**From:** Whittingham, Gideon  
**Sent:** 23 February 2015 13:53  
**To:** Planning  
**Subject:** FW: 2014/5285/P - 39 Rosslyn Hill - obj  
**Attachments:** Planning app 2014-5285-P comments 29th Sept 2014.pdf; App 2014-5285-P dwg section AA.JPG

**From:** Martin McNair [mailto:[REDACTED]]  
**Sent:** 05 January 2015 12:43  
**To:** Whittingham, Gideon  
**Cc:** Stark, Stephen (Councillor); [REDACTED]  
**Subject:** RE: 2014/5285/P - 39 Rosslyn Hill

## **Camden Planning Application 2014/5285/P**

Drawing title: **PROPOSED SECTION AA**

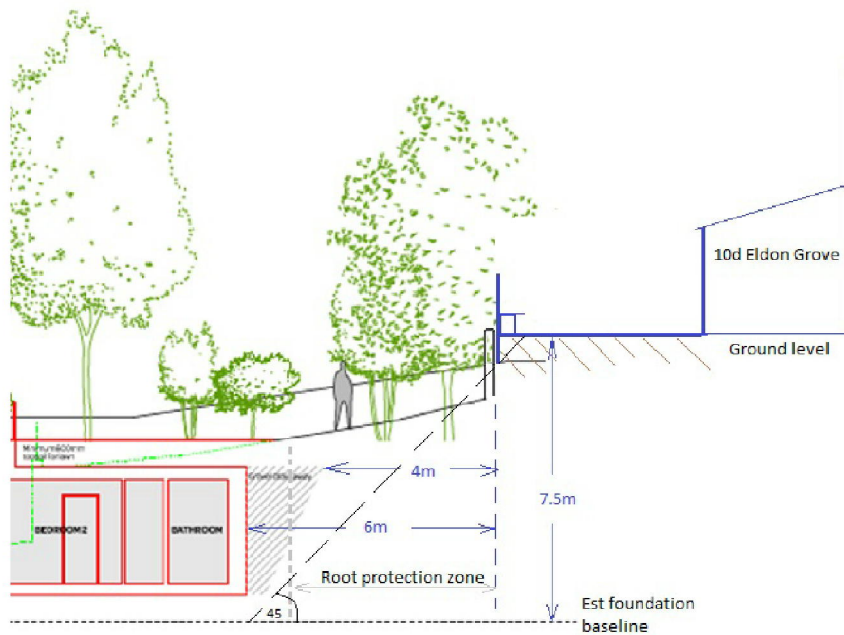
3. More critically, the methods statement does not take account of the true slope of the land and the actual height differential relative to our property. I attach a drawing 'section AA' which illustrates this. Although our measurements are not the result of a digital survey, we believe them to be conservative estimates. This would place the base of the foundation excavations some 7.5m below the ground level of 10d Eldon Grove and just 4 to 5m distant from our boundary wall, as per the drawing. We are very concerned that, as part of the independent assessment (mentioned in your email), the structural consequences of this aspect should be given full consideration, particularly as to how such a steep slope would be properly secured.

5. We are particularly anxious that the mature trees at the end of the applicant's garden are not threatened by the development. The arboricultural report submitted in September addresses this and proposes root protection zones. The dashed grey vertical line on the attached drawing (Section AA) shows the extent of the protection zone, as we understand it. It shows that part of the excavation will compromise the area recommended for protection. We have considerable concern that any additional retaining wall, such as king post or sheet piling or other reinforcement will be even more intrusive and threaten the trees. As presented, the revised drawings are insufficiently detailed and make this difficult to assess.

6. Although it may not be a specific matter for the planning approval process, we hope the applicant and agent will be made aware of the need for party wall agreements with the neighbouring property owners. In our case, it will be needed (contrary to the comment in 2.5 of the BIA) as a 45 degree line taken from the base of the proposed foundation excavations - and certainly any reinforcing wall - will intersect the foundations and boundary walls to the rear of 10d Eldon Grove.
